L-2016-107
10 CFR 50.12
10 CFR 52.63

Re: Florida Power & Light Company
Proposed Turkey Point Units 6 and 7
Docket Nos. 52-040 and 52-041
Endorsement of Supplement 2 to Voluntary Submittal of Exemption Request and
Design Change Description for Departure from AP1000 DCD Revision 19 to
Address Containment Condensate Return Cooling Design

Florida Power & Light Company (FPL) hereby submits its request for exemption and associated design change description to address a design change to the AP1000 Design Control Document (DCD) Revision 19. The design change requires Nuclear Regulatory Commission (NRC) notification and review in accordance with Interim Staff Guidance DC/COL-ISG-011, "Finalizing Licensing-Basis Information." The Turkey Point Units 6 and 7 Combined License Application (COLA) incorporates the AP1000 DCD by reference.

Figure 3.8.2-1R, Containment Vessel General Outline

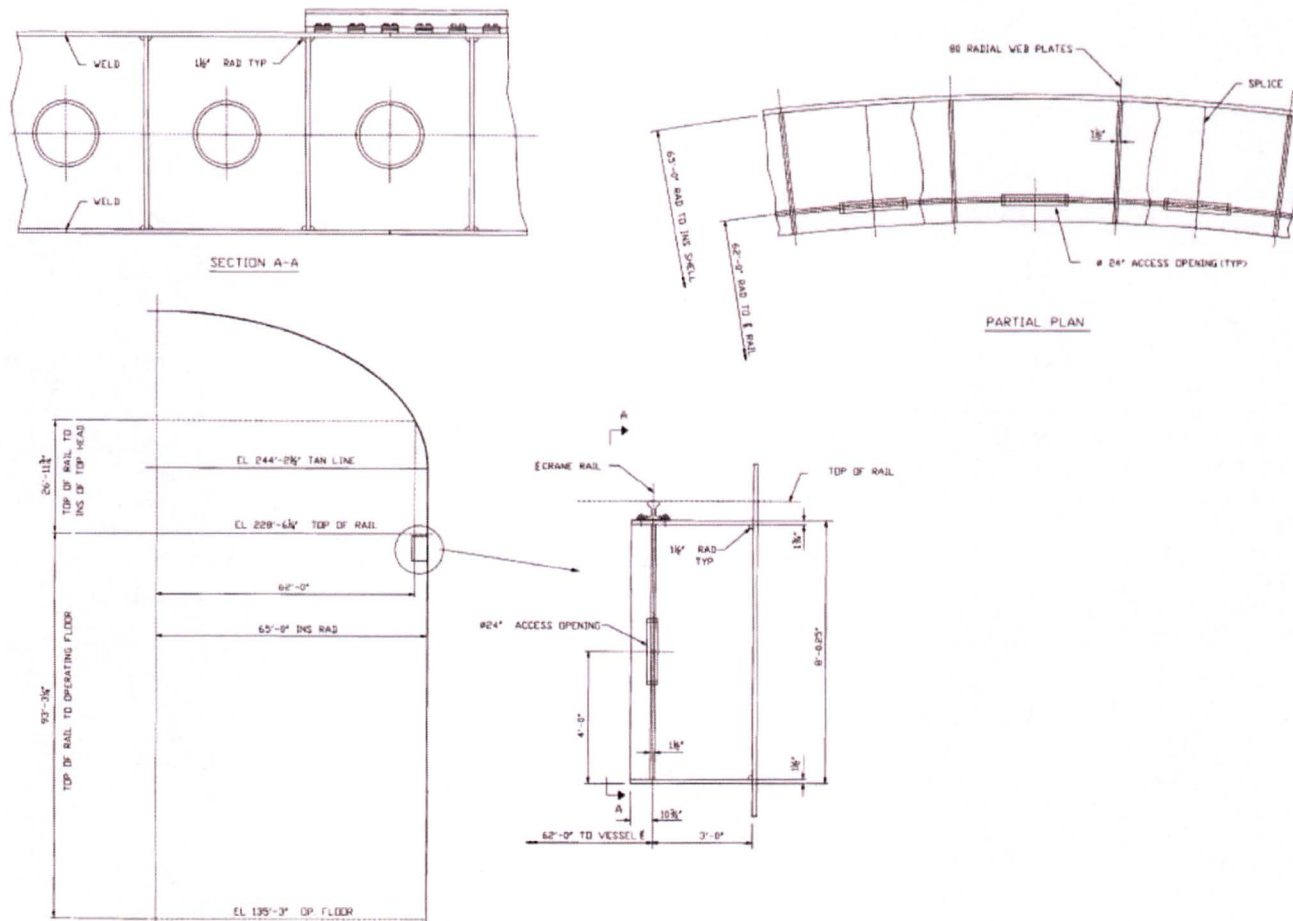
Pictorial detail of the Polar Crane Girder is shown in DCD Figure 3.8.2-1 (Sheet 3 of 3), Containment Vessel General Outline, and shows the fabrication holes in the top right figure. As the fabrication holes in the PCG would be blocked in the modified configuration, this detail would be removed from this figure.

5. COLA Part 2, FSAR Chapter 3 will be revised to add Figure 3.8.2-1R with a left margin annotation of PTN DEP 3.2-1 as follows (departure from DCD Figure 3.8.2-1 (Sheet 3)):

Figure 6.3-1R, Passive Core Cooling System Piping and Instrument Diagram, (Sheet 1 of 3)

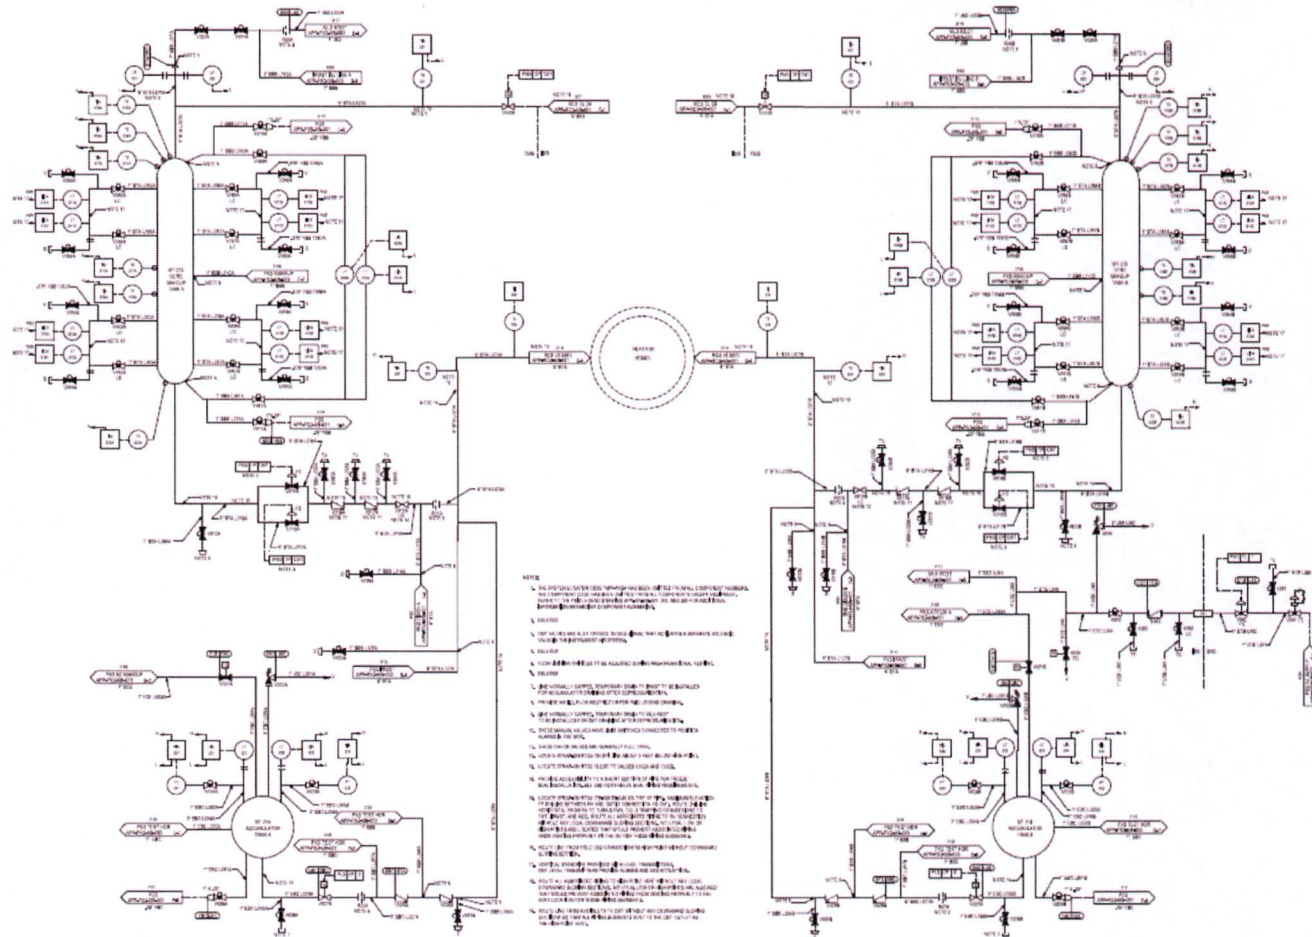
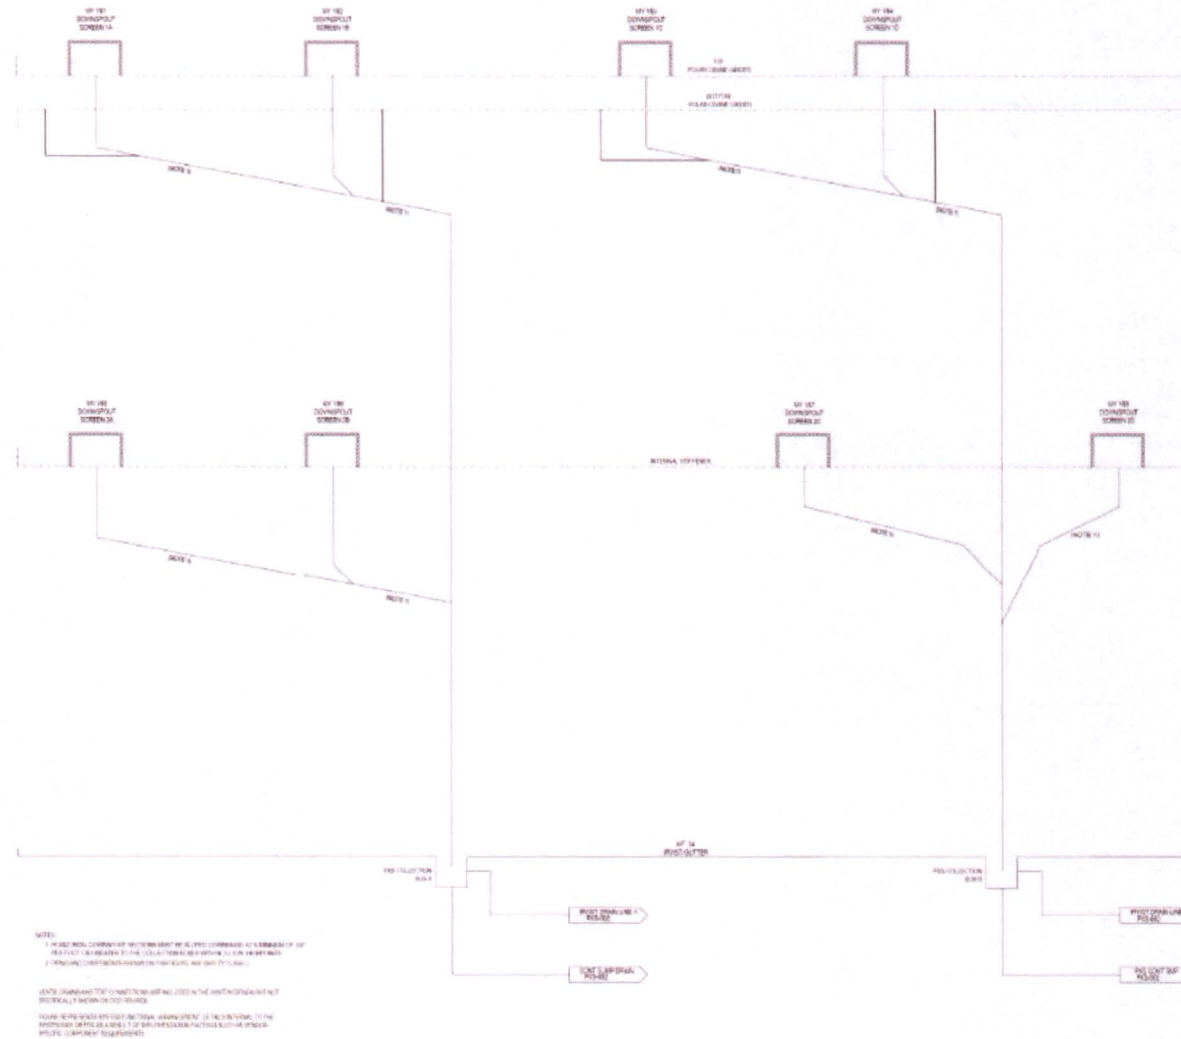
To reflect the changes to the PXS system, the additional downspout piping is captured in the gutter discussion of DCD Subsection 6.3.2.1.1 and on a new sheet of the PXS piping and instrumentation diagrams (P&IDs). In order to add the new P&ID sheet to the licensing

basis, Figure 6.3-1, Passive Core Cooling System Piping and Instrumentation Diagram, will be expanded to include continuation flags for condensate returning to the IRWST originating from PXS Collection Boxes A and B in the IRWST gutter (Sheet 2) and show the relocated IRWST gutter and the screens and piping comprising the PXS downspouts originating from the Polar Crane Girder and internal stiffener (Sheet 3). Subsection 6.3.1.1.1 will be updated to describe the downspouts in the safety-related design criteria, subsections 6.3.2.2.7 and 6.3.2.2.7.1 will be updated to clarify the number of screen sets in the PXS and to which set of screens the criteria in this section apply, and subsection 6.3.2.2.7.2 will be updated to clarify the condensate return gutter arrangement related to LOCA operation.

22. COLA Part 2, FSAR Section 6.3 will be revised to add Figure 6.3-1R with a left margin annotation of PTN DEP 3.2-1 as follows (departure from DCD Figure 6.3-1 (Sheets 1 through 3)):

PTN DEP 3.2-1 Figure 19E.4.10-1R, Shutdown Temperature Evaluation, RCS Temperature

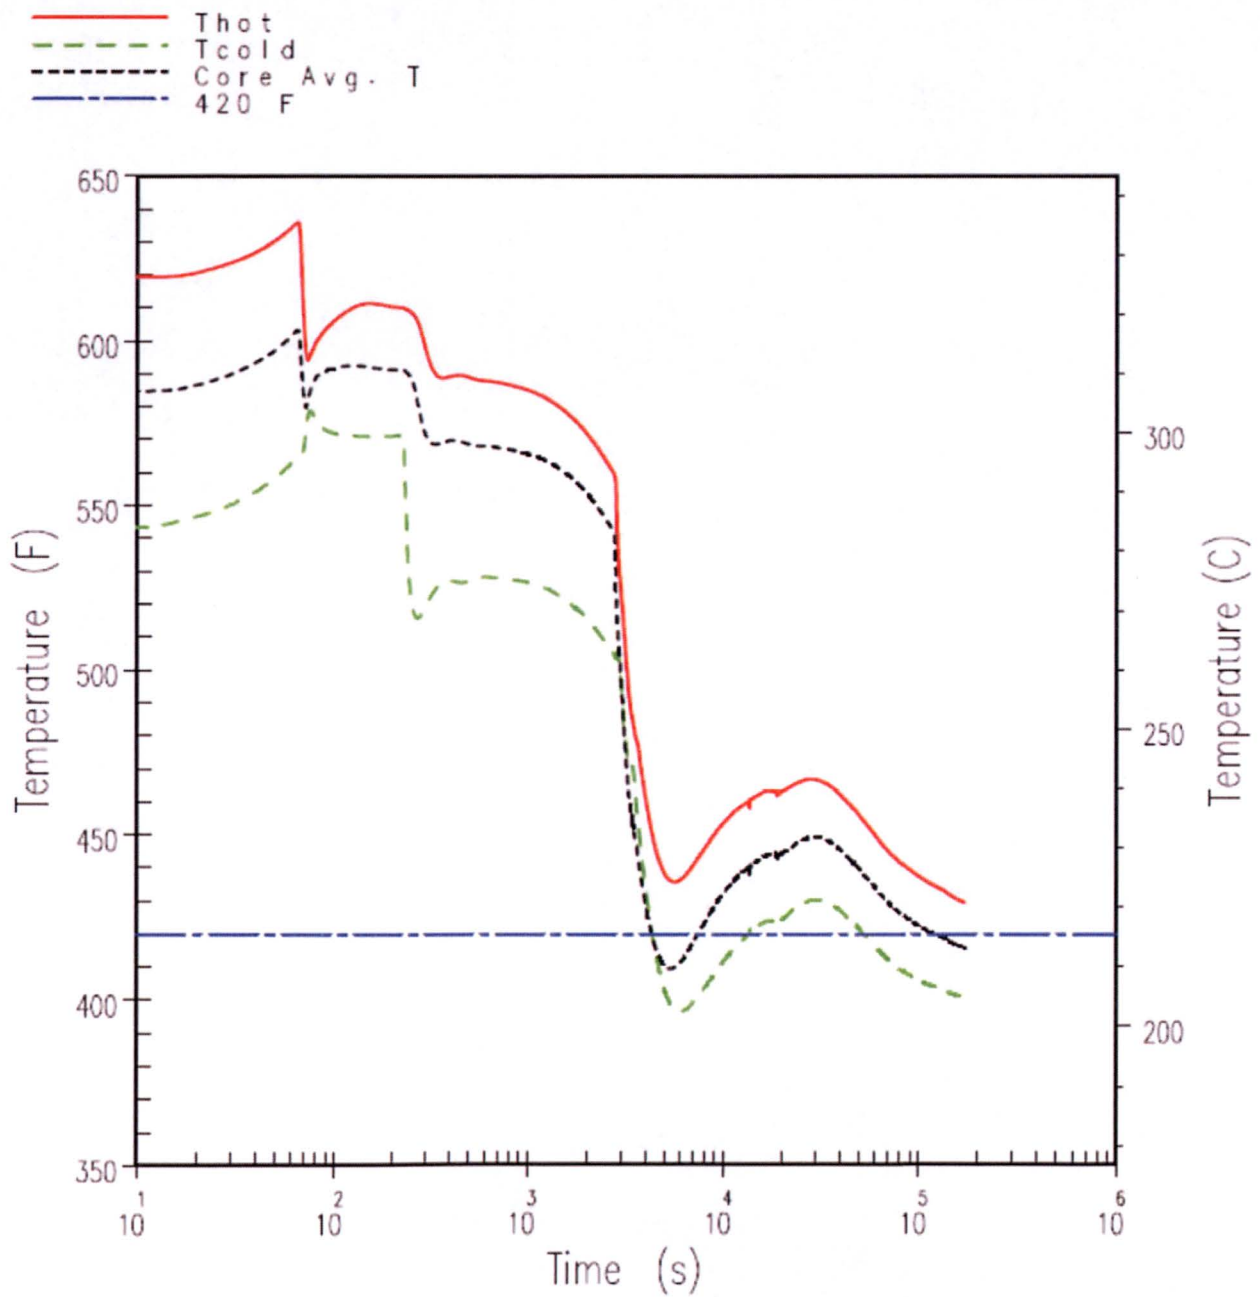
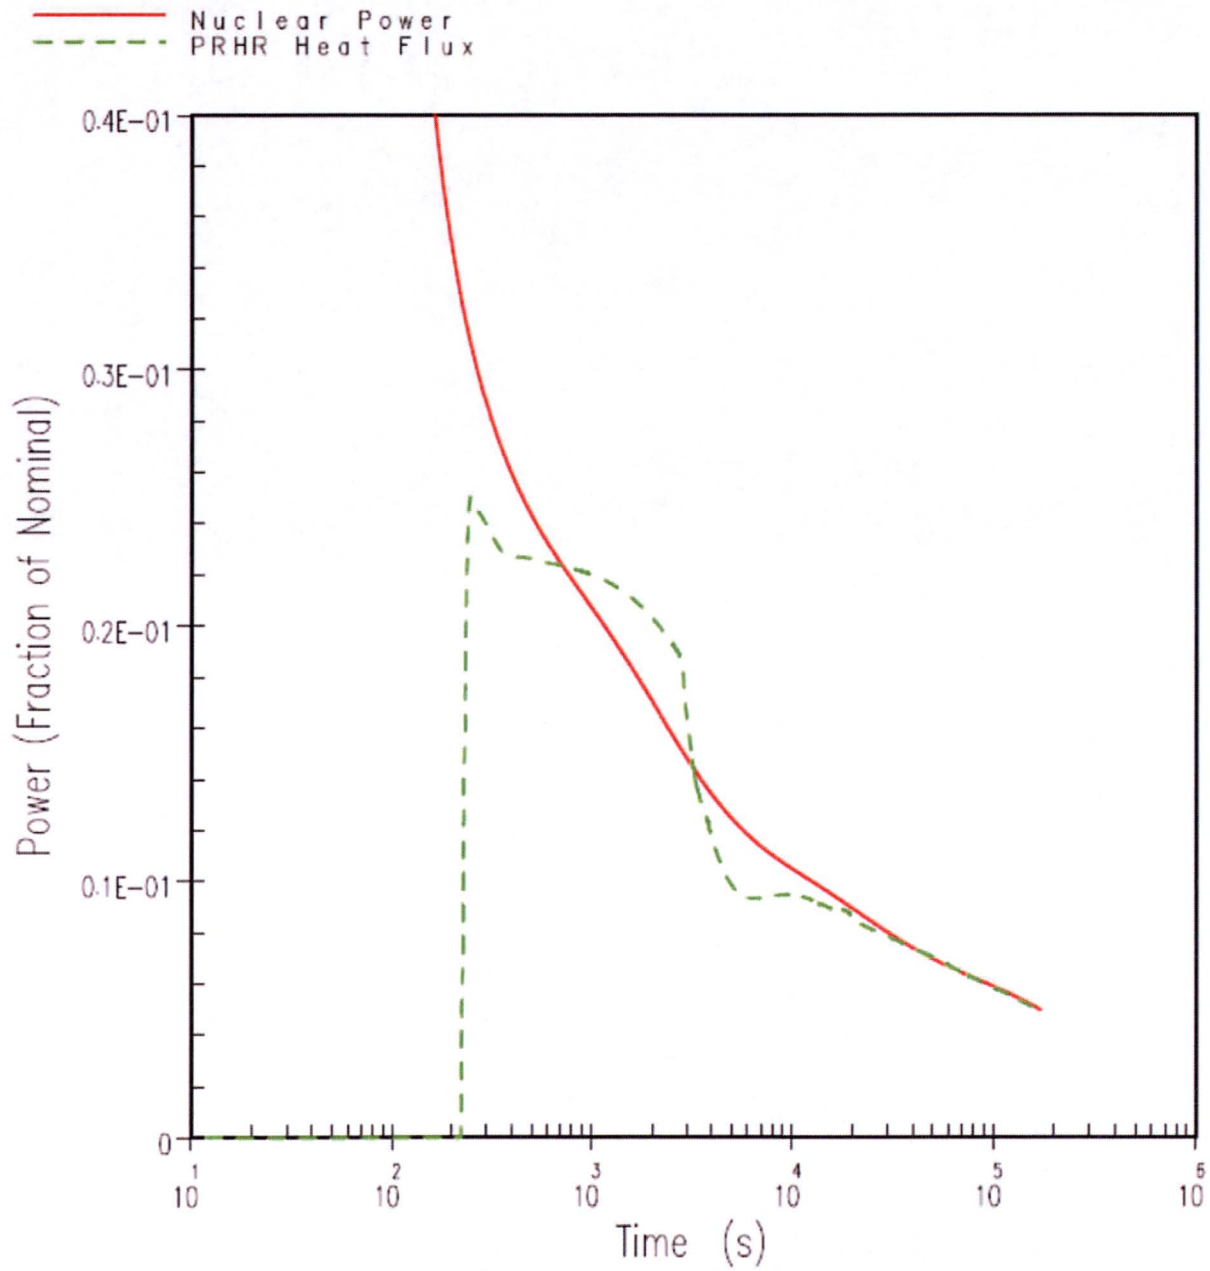
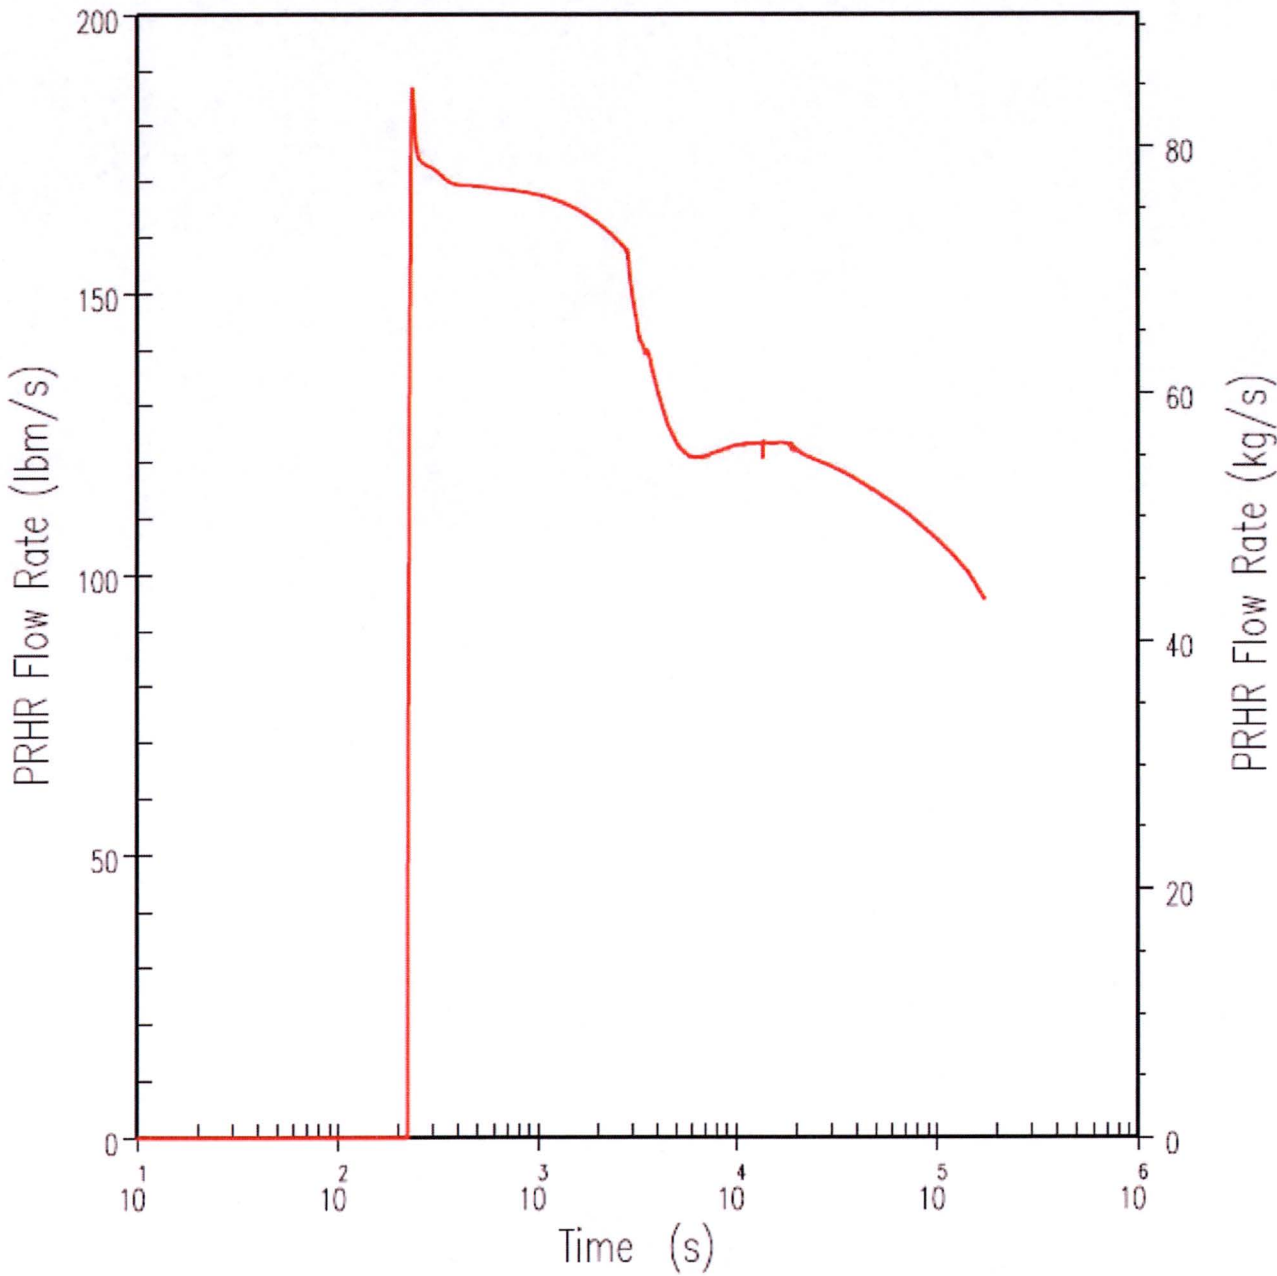
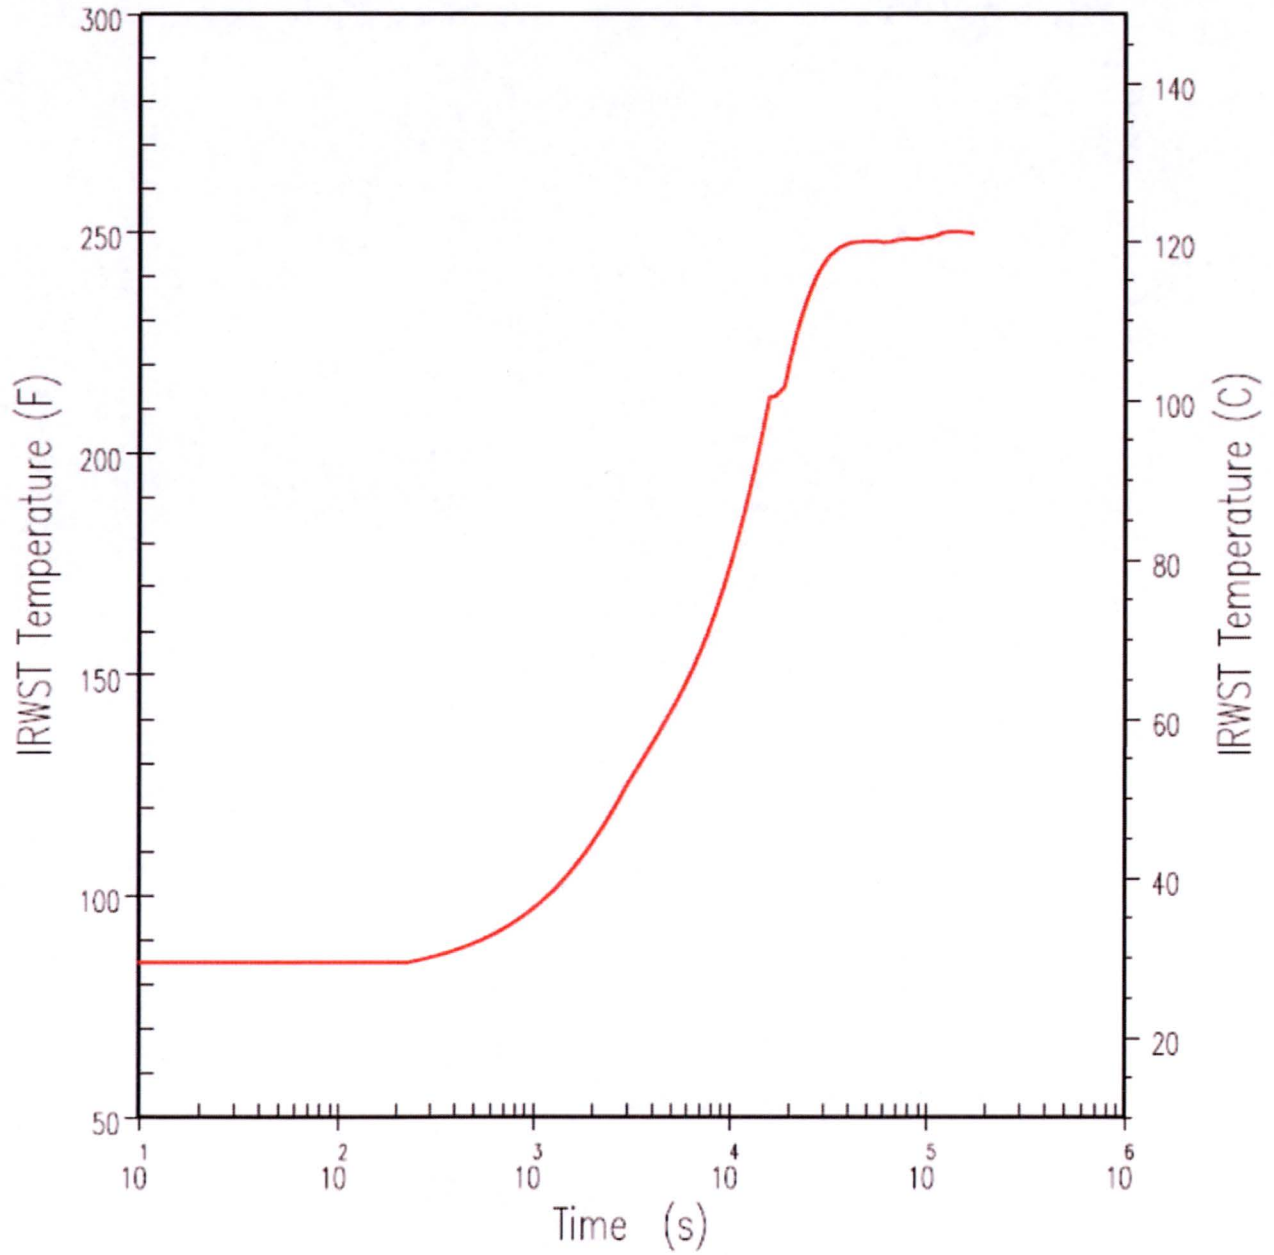
The safe shutdown temperature evaluation was revised to address the effects of the design modifications and supporting analyses and calculations of condensate return to the IRWST on PXS performance. The revised evaluation is reflected in the description provided in section 7.4 and subsection 7.4.1.1. The resultant changes to the Chapter 19 shutdown temperature evaluation are shown in text revisions to subsection 19E.4.10.2, changes to Table 19E.4.10-1, and changes to Figures 19E.4.10-1 through 19E.4.10-4.

Once actuated, at about 2,700 seconds, the CMTs operate in recirculation mode, injecting cold borated water into the RCS. In the first part of their operation, due to the injection of cold water, the CMTs operate in conjunction with the PRHR HX to reduce RCS temperature. Due to the primary system cooldown, the PRHR heat transfer capability drops below the decay heat and the RCS cooldown is essentially driven by the CMT cold injection flow. However, at about 6,000 seconds, the CMT cooling effect decreases and the RCS starts heating up again (DCD Figure 19.E.4.10-1). The RCS temperature increases until the PRHR HX can match decay heat. At about 46,700 seconds, the PRHR heat transfer matches decay heat and it continues to operate to reduce the RCS temperature to below 420°F within 36 hours. As seen from DCD Figure 19E.4.10-1, the cold leg temperature in the loop with the PRHR is reduced to 420°F at about 52,900 seconds, while the core average temperature reaches 420°F at about 120,900 seconds (approximately 34 hours).

32. COLA Part 2, FSAR Appendix 19E is revised to add Figures 19E.4.10-1R through 19E.4.10-4R, with left margin annotation of PTN DEP 3.2-1 as follows (departure from DCD Figures 19E.4.10-1 through 19E.4.10-4):
